Product Change Notification (PCN)

PCN #: 7B-2020

DATE: 7/22/2020

5.1 Top Level Part Number Changes (packaged kits)

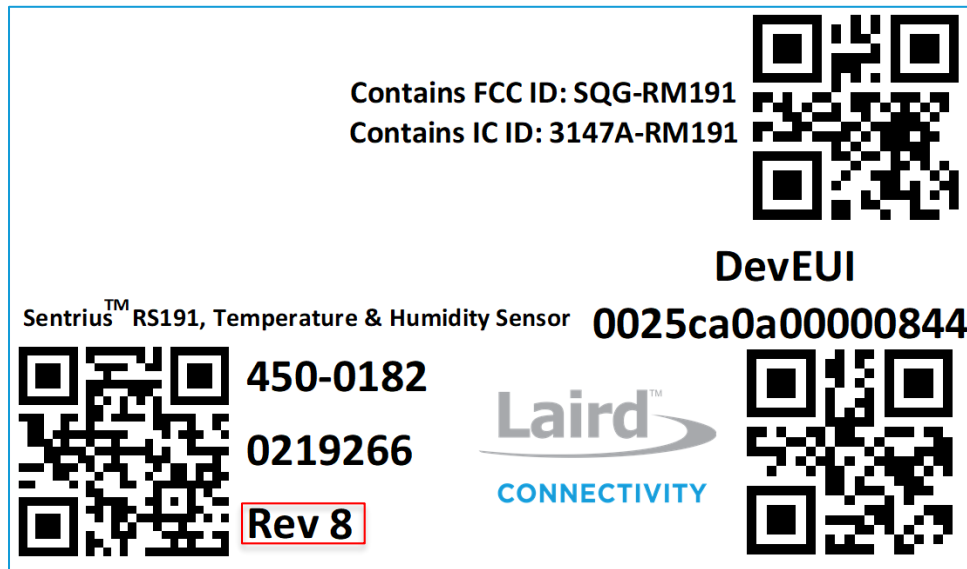
- Latest revision changes available as revision number printed on kit content label for all kits (Label located on the bottom left corner of the base kit label). Specific kit part number and revision printed on the label within red square area.

Note: Label located on the bottom right corner of the kit base label contains the same label info as printed on the sensor contained within the specific kit ([On Sensor Changes](#) section).
